LANDSCAPE RESPONSE

COUNCIL COMMENTS

LAND AT WITHINGTON COURT, WITHINGTON, HEREFORD, HR1 3SB

PLANNING RECONSULTATION REF: 200207

Figure 1: Comparison of landscape plans. Original scheme (left) and revised scheme (right)

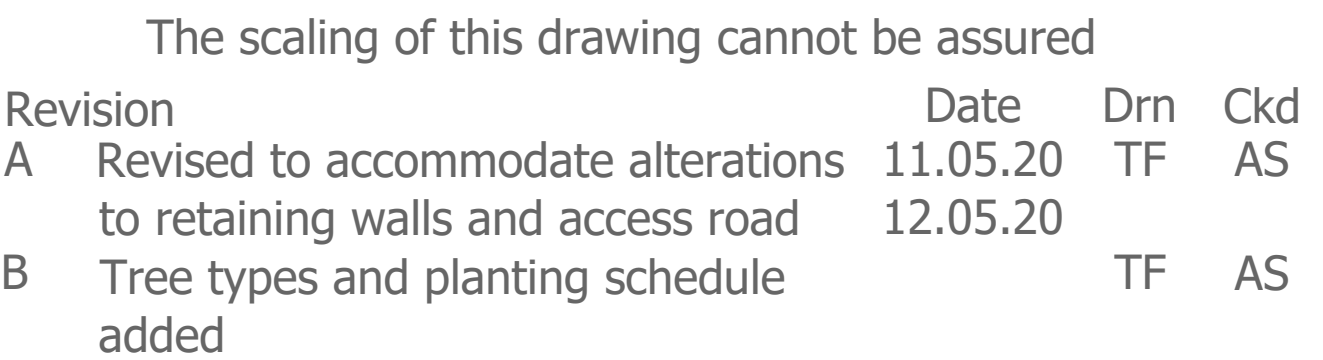
A fundamental issue is that the majority of the development is located at the southern part of the site which has the steepest topography (Refer to figure 2) of the site and Withington. The open countryside of the Principal Settled Farmlands is impacted by a 'wall' of buildings, a visual intrusion on the skyline exacerbated by the steep terrain, contrary to NPPF 12, 170 b, c and d, and local policy (Core Strategy) LD1.

In addition, with gradients of approximately 1:6 to 1:8, there will be significant excavation and associated earth battering and retaining systems. This may provide cumulatively visual impact; impact on natural hydrological systems and potentially restrict the ability to provide effective green infrastructure, in accordance with NPPF 14, 150a and local policy (Core strategy) LD1 and LD3.

It is acknowledged that the reduction of houses does increase the area of open space and draws the development away from the top of the land and therefore is an improvement in this respect, however it does not address the fundamental issue of development on a steep slope; the proximity to dwellings on the southern boundary and overall landscape impacts on the countryside. In fact, when comparing the two schemes (Figure 1) it appears that the revised scheme densifies the development in the most sensitive part of the site and has an overall adverse impact on the Principal Settled Farmlands landscape character, contrary to NPPF 15, 170a and local policy (Core Strategy) LD1.

- 2.18 The findings of the AAH Addendum (Appendix C1) predict **minor adverse** effects arising for Topography, Geology & Soil Type, Land-Use, Spatial Character & Enclosure Pattern, Field Boundaries & Tree Cover and Landscape Quality at the **residual stages** of the Development. Overall, the AAH Addendum acknowledges that the Development would impose change but that it would have the greatest influence at close-range due to the enclosed nature of the Site. Furthermore, with the Development being adjacent to the residential edge of the Withington built environment, the change would result in only a minor alteration to the landscape character resulting in a low magnitude of change and a **minor adverse** significance of effect on the Principal Settled Farmlands LCT and on the Herefordshire Lowlands NCA.

- 2.20 The design has been developed to allow for appropriate gradients to meet acceptable standards. In terms of visual matters, the AAH Addendum (Appendix D1) predict **moderate adverse** effects arising Viewpoint VP08A from the C1130 looking north and Viewpoint VP08B from the C1130 looking south. These receptors would perceive a small part of the completed western access to the Development where the loss of the hedgerow (group G1) and earthworks would be the noticeable element in the view. Mitigation measures would, however, be applied that would include new native tree and shrub planting along the Site frontage as shown on the plan at **Appendix C**. There would also be new tree planting within the central-upper northern parts of the Site to assist with the integration of the Development along the C1130 and Withies Road. The new planting, in particular, would be arranged in groups as small woodland areas to provide softening rather than screening of the new housing. There would be **minor adverse** effects arising from Viewpoint VP03A from the C1130 at the junction with Southbank, however mitigation measures would include new planting along the lower south-western portions of the Site. From Viewpoints VP06A and VP07A there would be **minor beneficial** effects since the provision of new open space within the northern part of the Site would provide an opportunity for a new recreation area to capture views out towards the surrounding landscape.

- 2.22 The Planning Re-consultation is for an outline planning application for residential development including means of access with all other matters reserved. The design is illustrative and can therefore be developed in character with the existing environment in terms of scale, massing and arrangement of dwellings. On balance, the Development would be set in context with the existing settlement edge of Withington to the north, south and west, which mainly comprises two storey dwellings and any extension would seek to reflect the character of this part of the settlement. The local topography can also assist the roofscape so that it would not visually dominate views across the area both towards and away from the settlement edge. Where the land rises at the northern end of the Site the

Landscape Planting Concept Plan

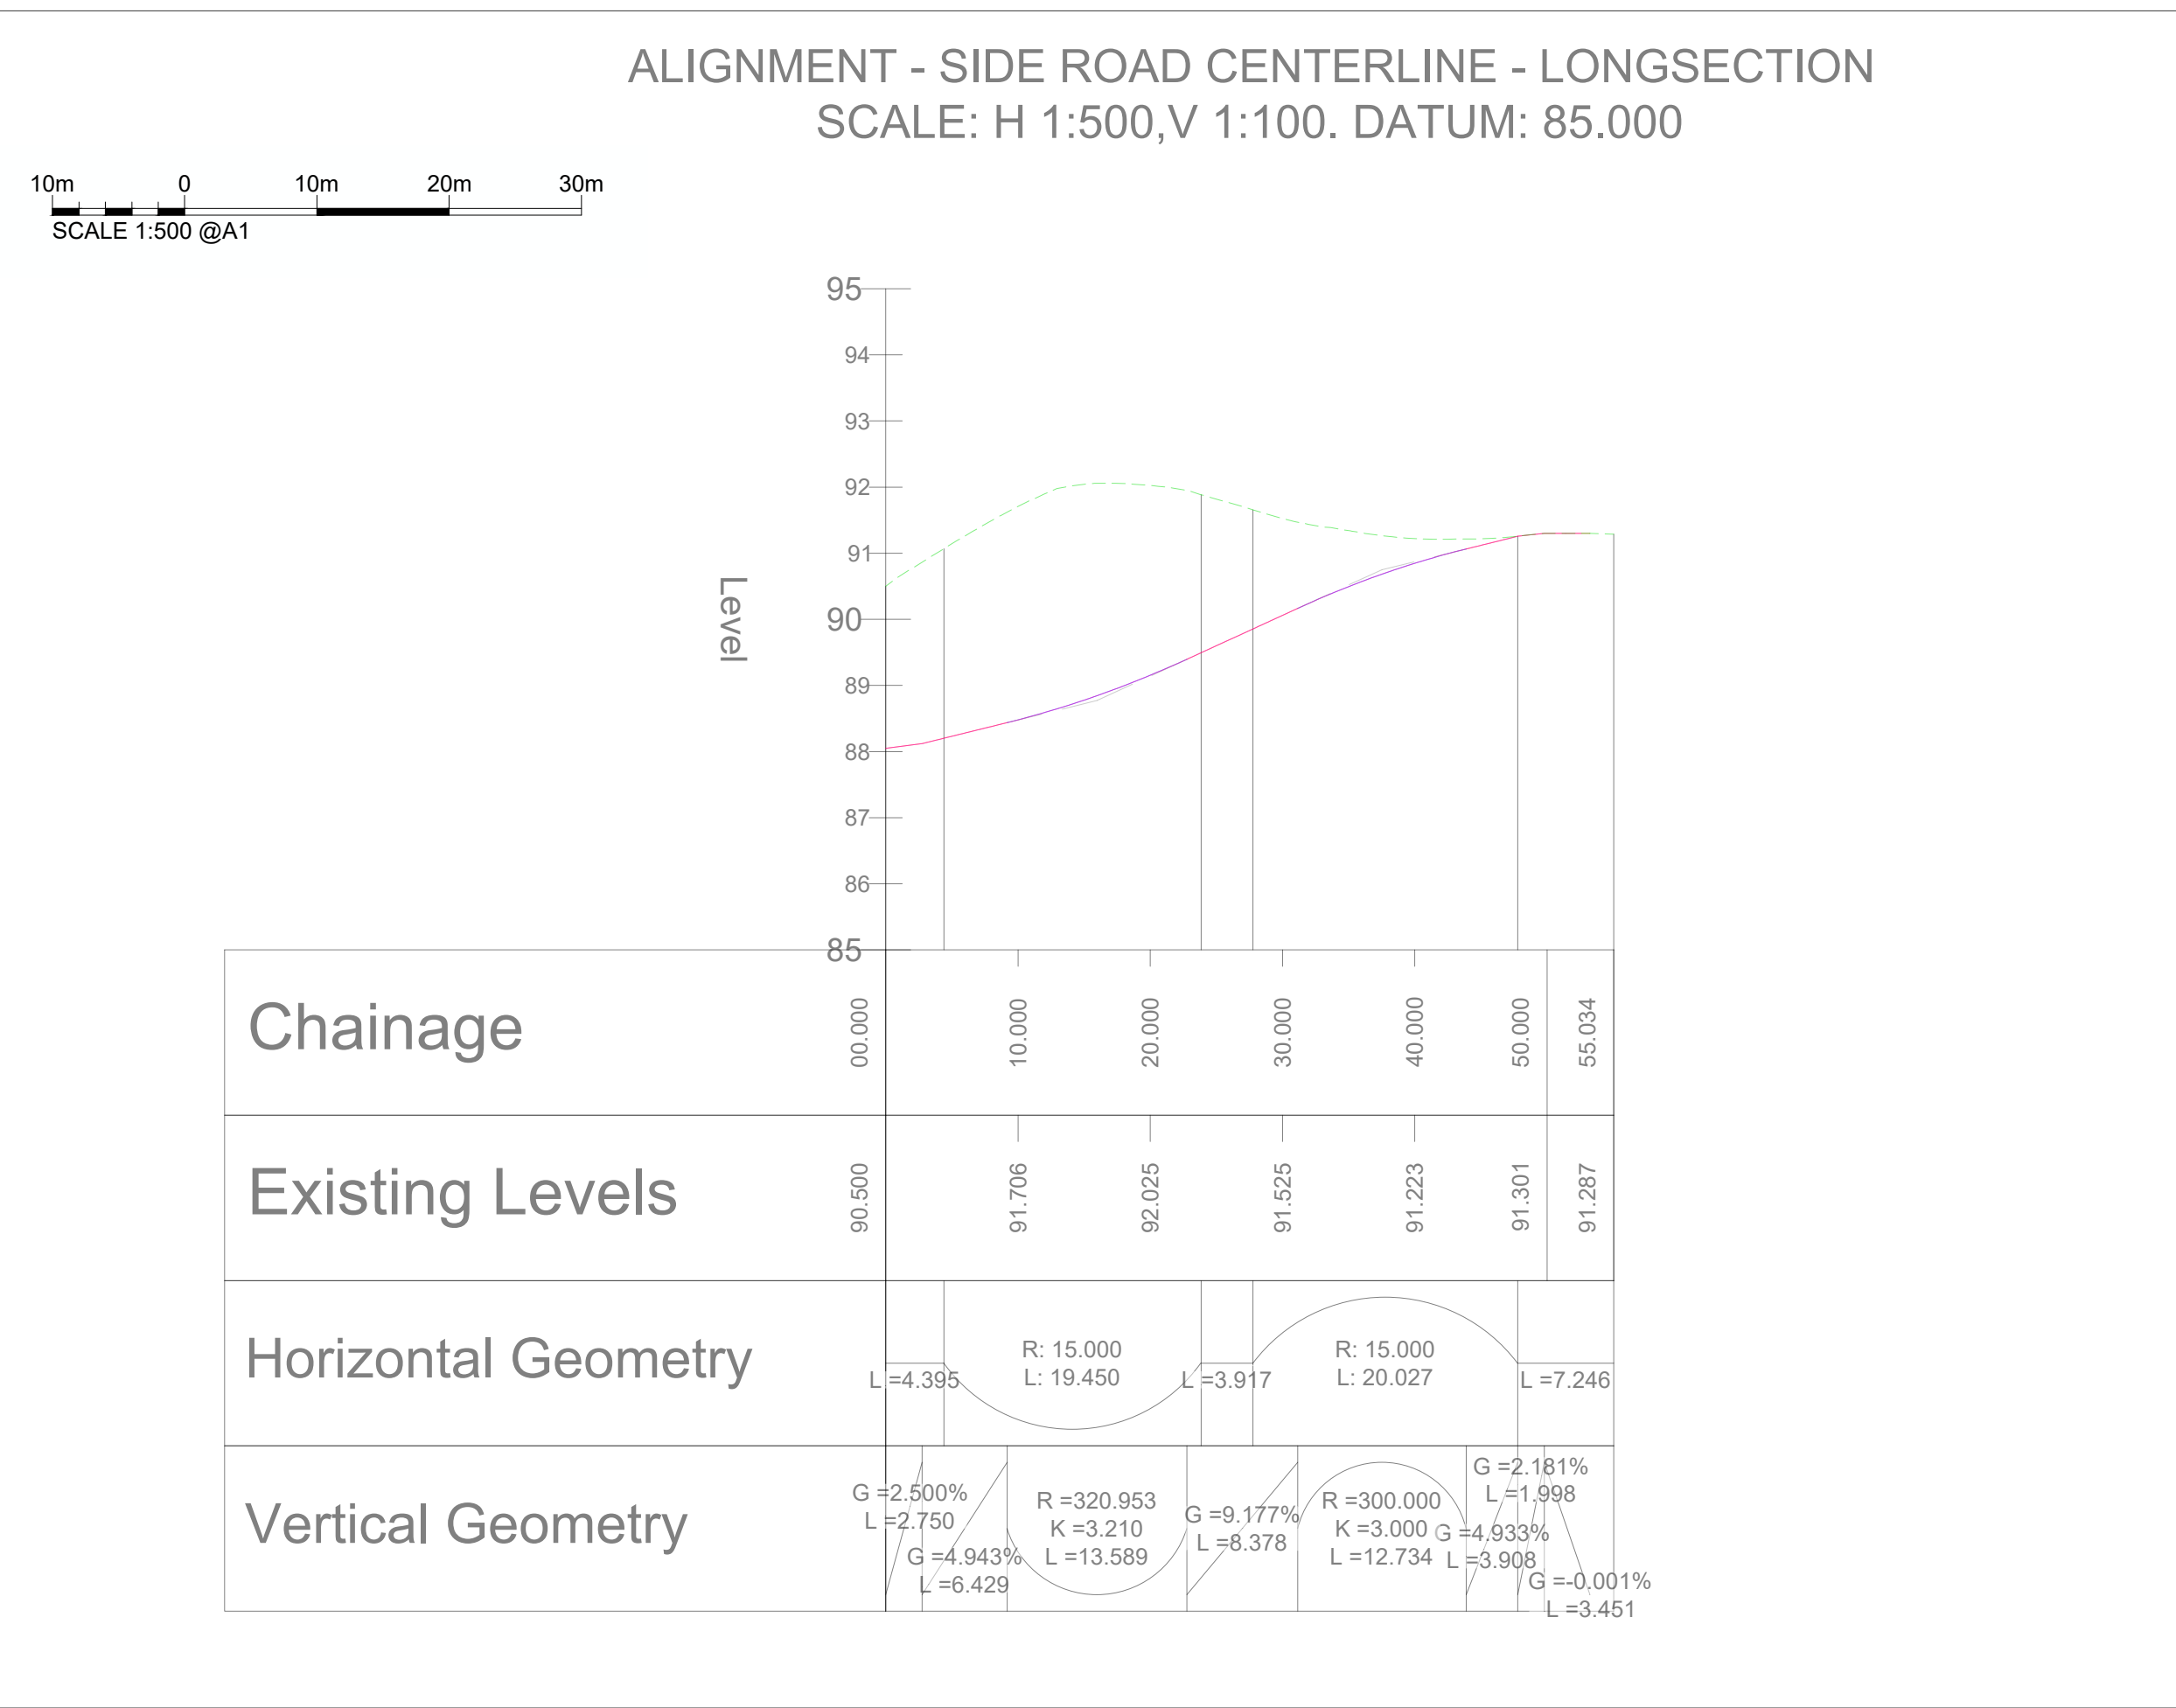
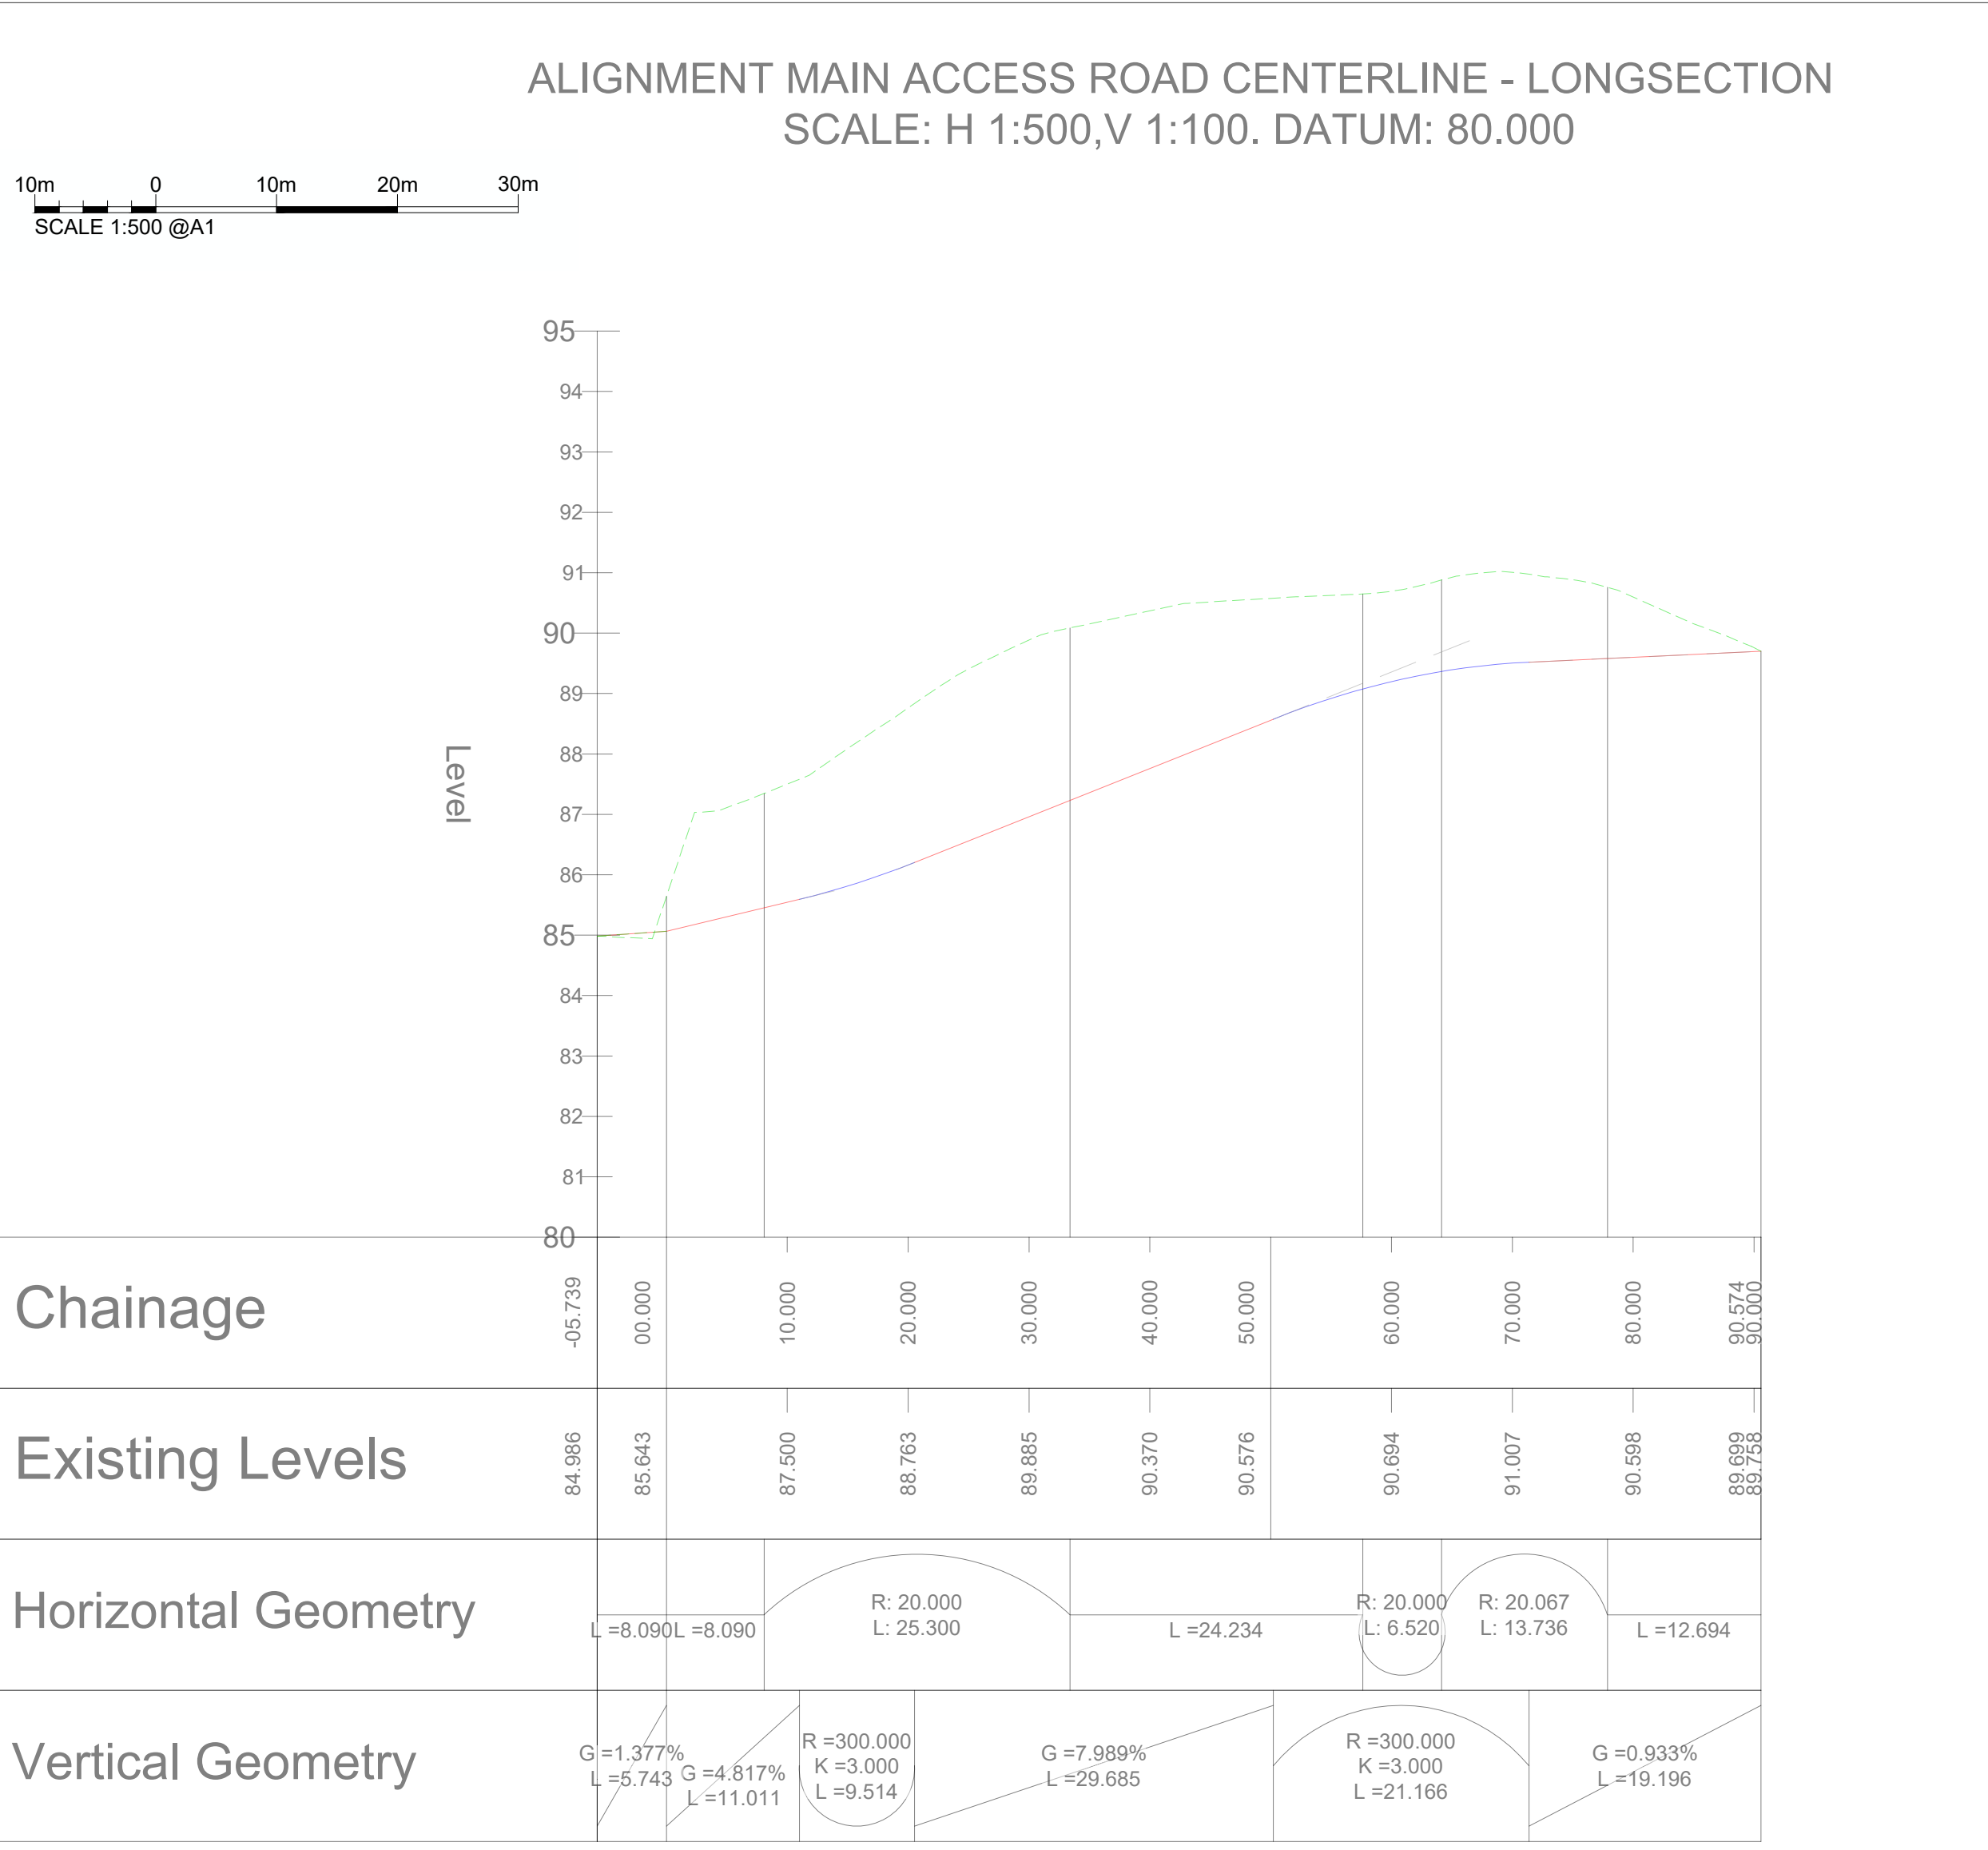
- 2.2 *The applicant has shown conceptual drawings that includes the intention to ‘soften’ the highway engineer’s retaining walls for the access (This is the preferred approach). However, to fully appreciate the removal of the retaining walls and how the levels and gradients look, and if this impacts the planting structure, the landscape drawings and engineering drawings would need to be coordinated... Further information of the ‘actual’ proposal is required.*

- 2.4 *The planting plan looks interesting as a zonal pattern, but how does it respond with actual species, densities and canopies? How does it respond to sight lines and vehicle visibility splay? And how does it respond to the levels, once the retaining walls are removed?*

2.6 ***The native species woodland mix (the zone next to the footpath) is relatively narrow and therefore in essence is a hedge. The species mix includes thorny species, and needs to be considered carefully next to a footpath. Please refer to the Herefordshire Council, Highway Design Guide for New Development, under 2.14 Landscaping, that states ‘Thorned species shall not be accepted immediately adjacent to footways or cycle tracks’ and review the species list accordingly.***

2.8 ***Regarding specimen trees, to make the sense of arrival more desirable, it may be worth considering locating these trees closer to the main access.***

- 2.3 The drawings at **Appendix C** are now updated to show a fully co-ordinated approach as to how the site gradients and the planting design would work in combination to deliver a well-designed solution for the new Site access. The drawings propose a series of stepped gabion retaining structures combined with new ground cover planting to naturalise the gabions and provide a softer appearance. The planting allows for ground cover to cascade from the upper areas over the gabion structures, the lower areas would also be planted as well as some planting pockets within. The tree planting has also been re-configured to accord with the new layout and help soften the effects of the gabion structures at the Site entrance.

- 2.5 Sight lines and visibility splays are now shown on the revised plans at **Appendix C** for fuller clarity. The proposed levels are also shown along with planting species and densities. In terms of tree canopies the design intention would be to create a layered structure to place the trees with the tallest canopies within the central regions of the planting zones, then stepping down towards the peripheral areas with a graduation towards an understorey layer including evergreen species at the edges of the planting zones. The planting design would be specifically arranged and species selected to create an informal, wooded character to the access road and to reduce visibility in all seasons in views towards the new housing from the

2.7 We have taken this requirement into account and revised the design to ensure that these thorny species are not positioned adjacent to footways. In addition, the planting specification on the drawing also notes that “*the final canopy of any thorned should be plant at least 3 metres from the edge of footways or roads*” as per the *Herefordshire Council, Highway Design Guide for New Development (July 2006)*.

2.9 This has been considered and several trees have been moved closer to the main access road. Refer to the Landscape Planting Concept Plan (**Appendix C**) which show species such as English Oak, English Elm, Rowan, Alder and Wild Cherry positioned closer to the Site frontage designed to provide an interesting combination of flowers in spring and fruit in autumn.
